WELL PLUGGING APPLICATION

Form	CP1 - Well Plugging Application
Operator	Merit Energy Company, LLC
Well Name	Dunkle A 1
Doc ID	1456521

ENGINEERING CONDITIONS OF APPROVAL FOR THE PLUG AND ABANDON SUNDRY

Well Name: Dunkle A #1 Lease No: KSNM 75249 Lse. #77181
Location: SE-SE Sec. 1, T33S-R41W Morton County, KS.
API Number: 15-129-20220
Operator: Merit Energy Company Date: April 3, 2019
Completed by Date: June 15, 2019

PROPOSED WELLBORE DIAGRAM

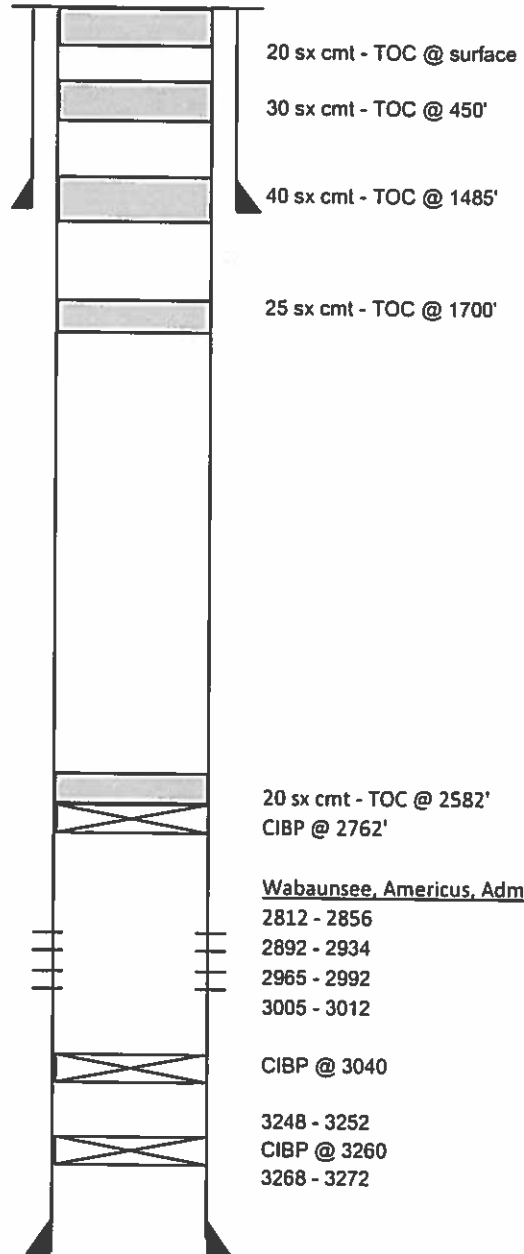
Assure BTW (?) to surface is covered with cement.
8.625" Surface Casing Shoe set at 1615'. Cement to surface.
4.5" Production Casing Shoe set at 3335'. TOC 1750', PBSD -CIBP @ 3040'
Top Perf: 2812'-3012'

1. MIRUPU, POOH with rods, pump, and tbg..
2. **Bottom Plug:** RIH w/4.5" CIBP and set at ~2762' (~50' above top perf) and cap with ~20 sxs. 15.3# Class "C" cement. Fill 4.5" casing w/9.3# mud as required. POOH with tbg.. WOC-Tag TOC ~2582' or higher.
3. **300' Stub Plug and Shoe Plug:** Weld on 4.5" casing, free point and cut 4.5" casing at ~1750' (TOC). POOH laying down 4.5" casing. RIH and spot 15.3# Class "C" cement 100' in 4.5" casing cut and 200' above the 8.625" surface casing shoe (~1850'-1415'). Note: The 4.5' casing cut can be between 1665' (50' below the surface shoe) and 1750' (TOC). WOC-tag cement shoe plug at 1415' or higher.
4. **BTW (?) Plug:** Spot BTW (?) 15.3# Class "C" cement plug from 100' below to surface.
5. Tag and Top off with cement, and cap.

Recommended Revised Procedure 4/3/2019
